AGENDA HISTORIC LANDMARKS COMMISSION

STAFF REPORT AND FINDINGS OF FACT

SUBJECT: NEW CONSTRUCTION REQUEST (NC16-06) BY JULIE AND PAT WILSON TO

HISTORIC STRUCTURE AT 331 EXCHANGE STREET

Franklin Ave

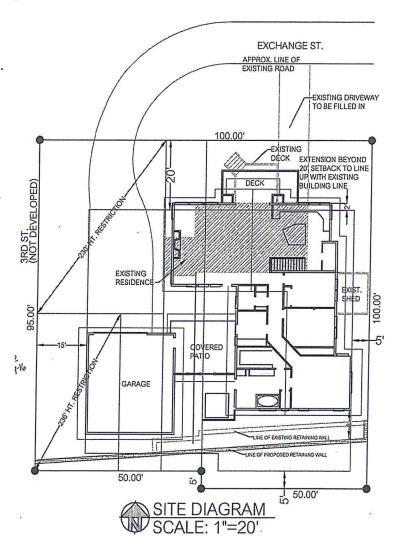
Setbacks: Minimum setbacks for corner lots in R-2 are as follows: front yard 20', side yard 15' on the street side, 5' side yard on the east side of the property and rear yard 5'. The applicant has proposed extending the front of the house to encroach into the 20' setback in order to line up the new development with the existing building line. However, because the existing building is being demolished, it is no longer considered expanding a non-

conforming structure
(Article 3.190D.
Destruction of
nonconforming structures).
The applicant shall either

adjust plans and behind the 20' setback or submit a variance request noting what hardship is occurring that necessitates building into the front yard setback.

- 1. Significant changes or modifications to the proposed plans as described in this Staff Report shall be reviewed by the Historic Landmarks Commission.
- 2. The applicant shall either adjust plans and build behind the 20' front yard setback or apply for a variance and prove a hardship in order to encroach in the minimum 20' front yard setback.
- 3. The applicant shall obtain a grading and erosion control permit from Public Works staff, and address storm water management.
- 4. The applicant shall submit for any necessary electrical permits to Clatsop County.
